SCHWEIZER SERVICE INFORMATION NOTICE

NOTICE NO. N-155.2*

DATE 20 January 1981

SUBJECT: REPLACEMENT OF PN 269A6092 OR 369A1602 TAIL ROTOR DRIVE FORK HINGE BOLT AND PN 269A6093 OR 369A1603 NUT; NEW ASSEMBLY PROCEDURE FOR TAIL ROTOR HUB AND DRIVE FORK UNIT; PERIODIC CHECK OF FLAPPING HINGE BOLT PRELOAD

Figure 1. Assembly and shimming - fork conical type bearings

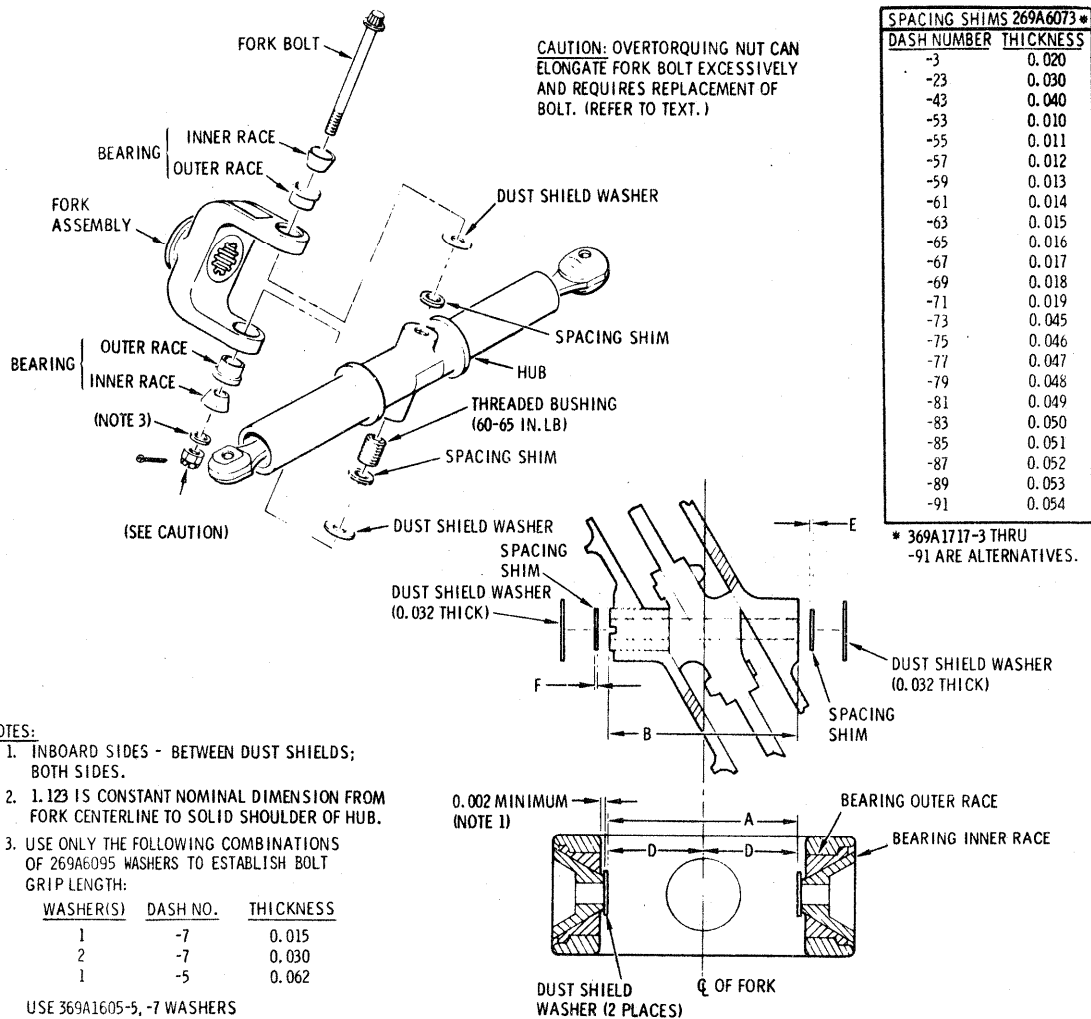
(2) Determine spacing thickness for centering the hub in the fork as follows (see example in Figure 1):

(c) Press dust shields firmly against bearing inner races. Measure distance between dust shields, then subtract 0.008 to 0.012 inch. Record this as dimension "A".

(d) Measure and record distance from solid shoulder of hub to opposite side (outer face of threaded bushing). Label this dimension "B".

(e) Subtract dimension "B" from dimension "A" to determine total required shim thickness (dimension "C").

- (f) Divide dimension "A" by 2; label this dimension "D".
- (g) Subtract 1.123 inches from dimension "D" to determine shim thickness for solid side of hub (dimension "E").
- (h) Subtract dimension "E" from dimension "C" to determine shim thickness for bushing side of hub (dimension "F").
- (i) Remove nut and fork bolt, while following bolt through fork with chamfered end of alignment pin.

(a) With the respective bearing inner race installed, start new PN 269A6092 or 369A1602 fork bolt through the bearings. Place spacing shims of correct combined thickness with dust shield washer at solid side of hub as shown in Figure 1. Position hub in fork; then slowly displace the alignment pin by pushing the bolt through fork and hub until bolt is flush with face of bushing. Light tapping with a soft mallet may be required.

(d) Install washer(s) and VCU0001 or 79325-428 nut on bolt. Use washer combinations shown in Figure 1 to establish bolt grip length and cotter pin hole alignment.
